## **ESA/ SCC QUALIFICATION REPORT FOR**

**ESA/SCC      4006/013 & 4006/014**

## **APPENDIX   E**

**Actual Causes of Non Conformance – NCCS. 2IEBET901**

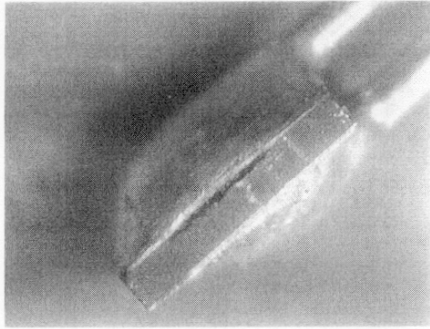
**Finding 5** - The company is requested to consider defining a process monitor at the operation welding the Pt-Ir leads of the 4006/014 devices.

**Cause:** There was no process monitor in place to check the integrity of the Platinum Iridium wire / weld joints. The Manufacturing Route Sheet has been changed to include the Weld Pull Test.

**SAMPLE A**

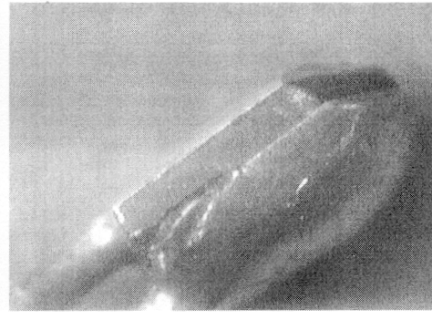
#### **Sample A : (Void in centre of edge )**

This part has the void in the centre of the chip along the edge of the ceramic / metallisation bond. Where the ceramic meets the metallisation there are eight edges. One of these edges shows a void. It appears that the metallisation has partially lifted away from the ceramic.

It is possible that the void was caused by damage to the metallization / ceramic layer during dicing . This would have been further exaggerated during the soldering process. However due to the limited inspection equipment it was not possible to determine fully what caused these defects. It was agreed to send these two parts to the Component Laboratory in ESTEC for further analysis.
